# Echotex (Extension) Ltd

6<sup>th</sup> December ,2016

# Observations

**Heavy Loading was observed on floors**

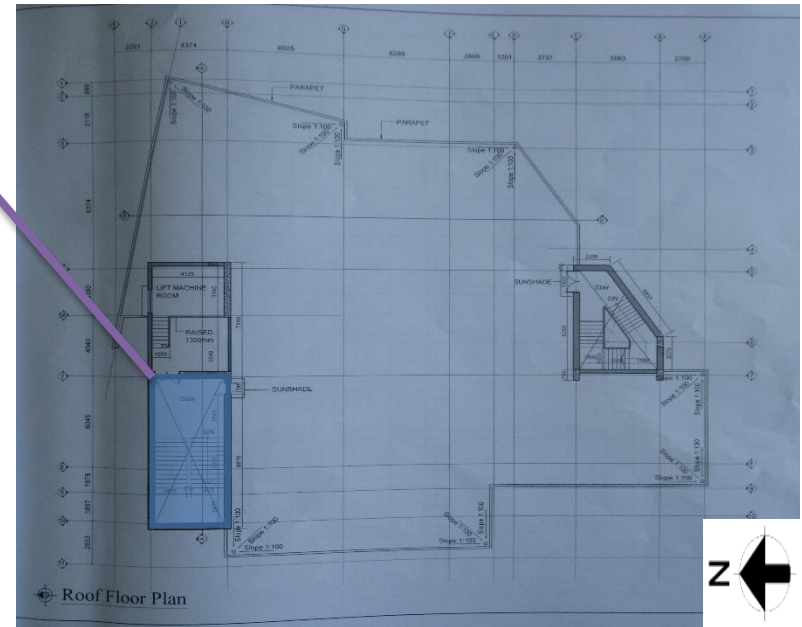
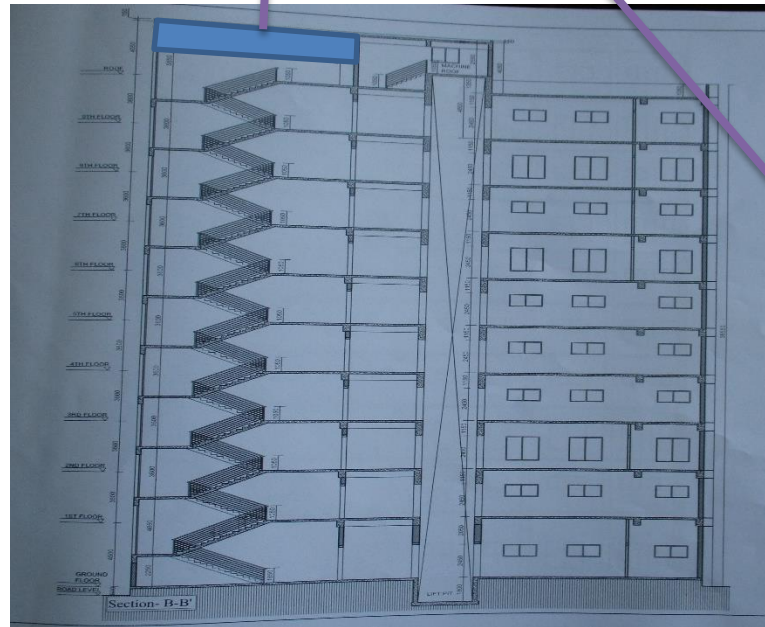
Heavy loading was observed on 9<sup>th</sup> floor which was measured as 102 psf on typical floor panel. Besides, Heavy loading was also found on several floors which exceeds 42 psf. A load plan was found where mentioned the floor capacity was 80 psf which required to review.

**Inconsistency between As Built Drawings and on-site condition**

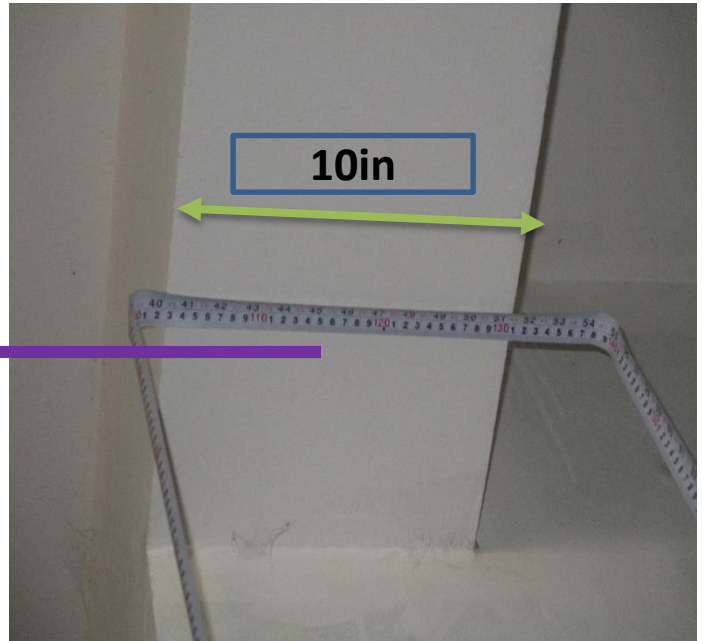
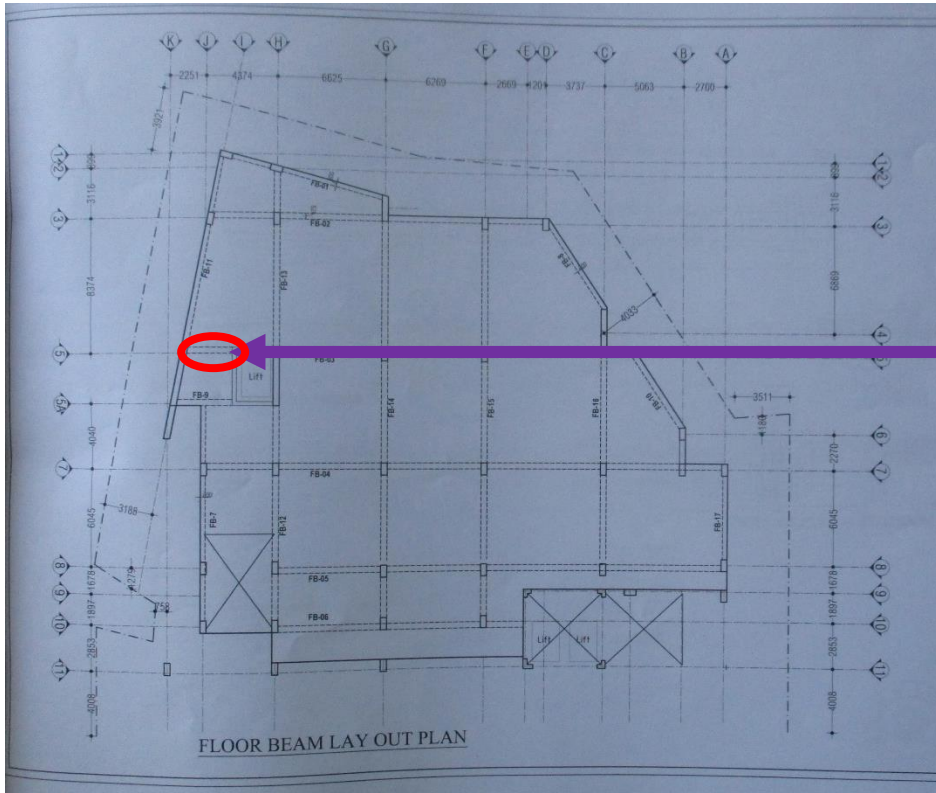
During inspection, RCC water Tank was observed on Roof which was not mentioned on As-Built Drawing

7	Inconsistency between As Built Drawings and on-site condition	Update As- Built drawing in accordance with actual condition and Incorporate the changes in As- Built Drawings.	6-weeks
8	Exposed Rebar on roof	All exposed reinforcement is to be protected from corrosion which may cause degradation of the concrete.	6-weeks

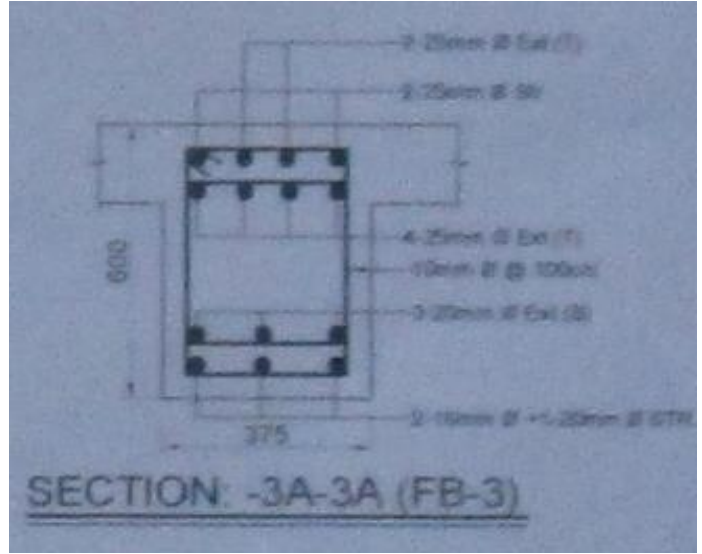
Floor Beam width of the highlighted portion was observed 10 inch instead of 15 inch on each floor

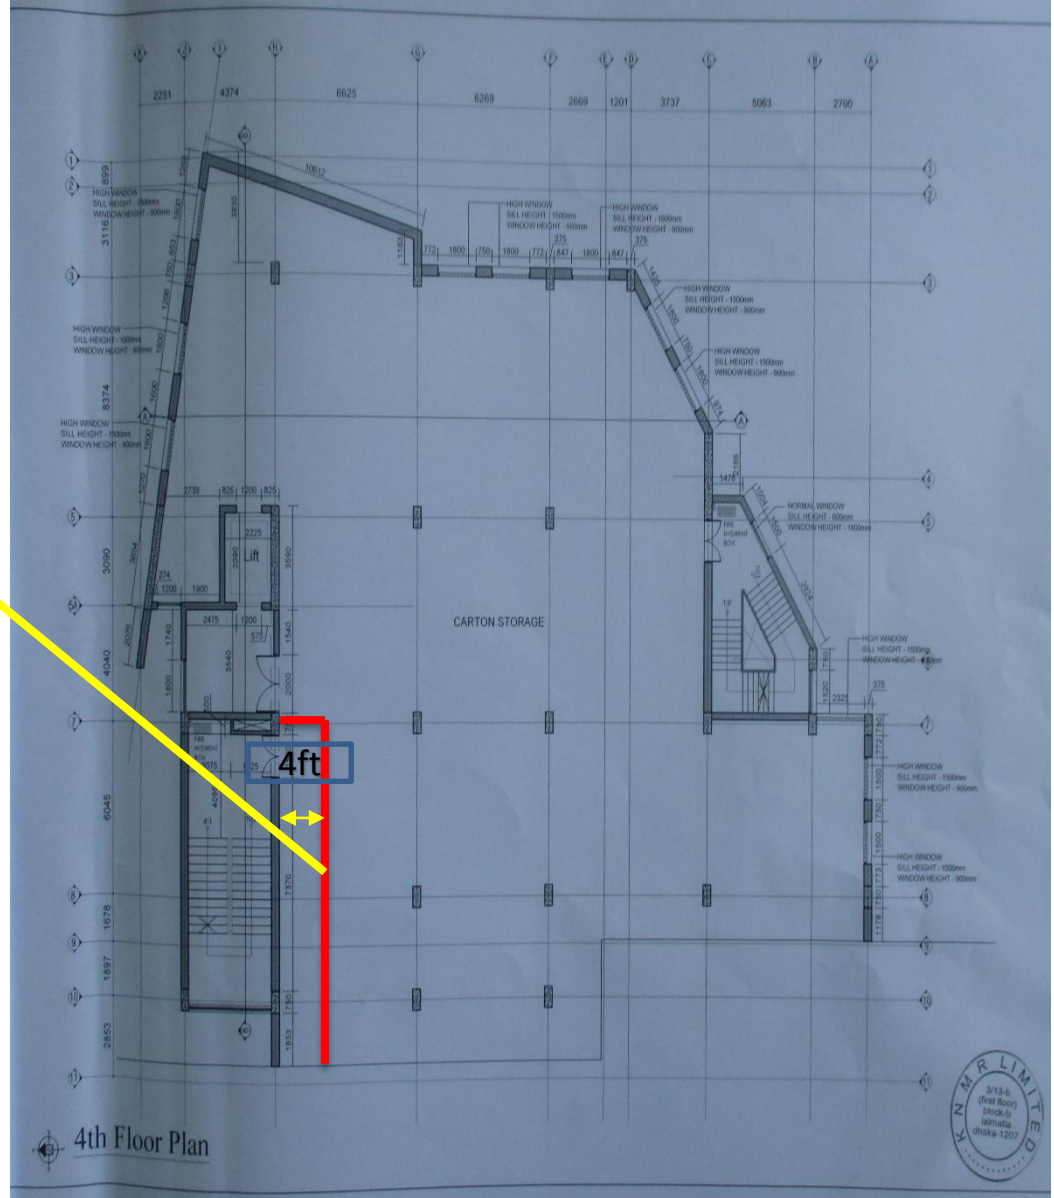
Additional brick wall (5 inch thickness) observed beside stair on 2<sup>nd</sup>, 4<sup>th</sup> & 5<sup>th</sup> Floor(not mentioned in As Built Drawings)

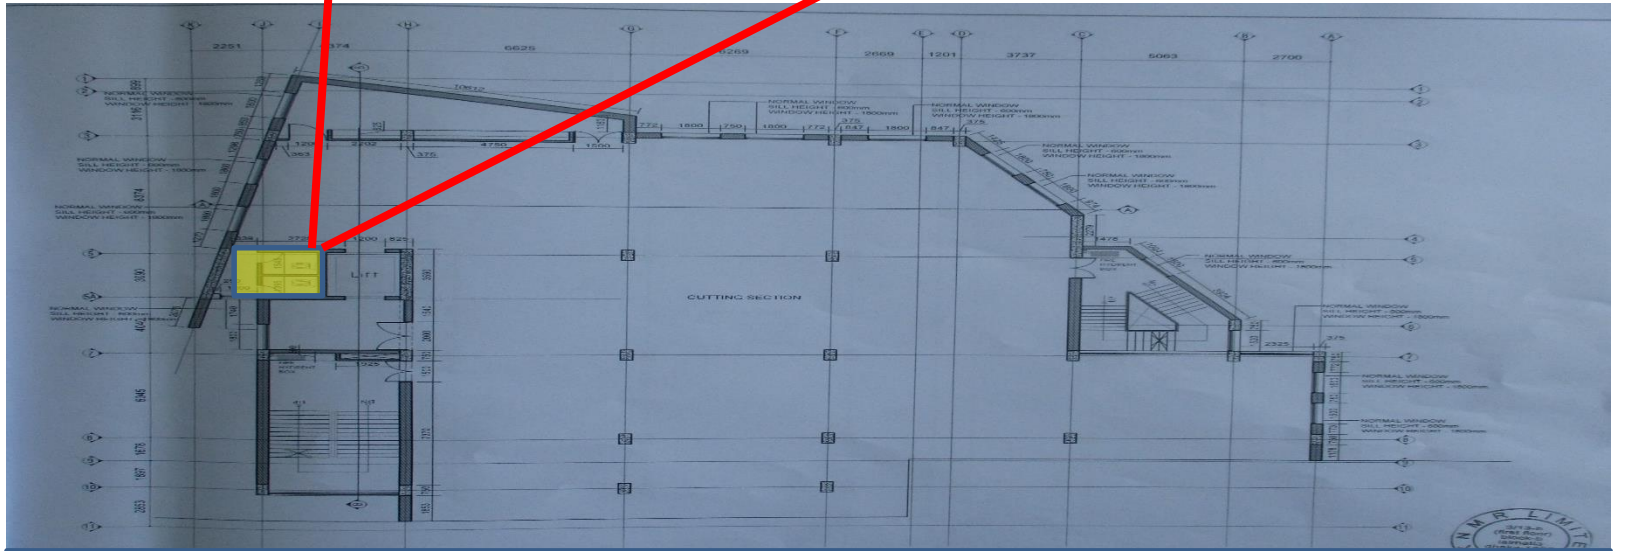
On As Built drawings Toilet Area was showed on highlighted portion of 8th, 6<sup>th</sup> and 2<sup>nd</sup> Floor but actually there was no toilet area.
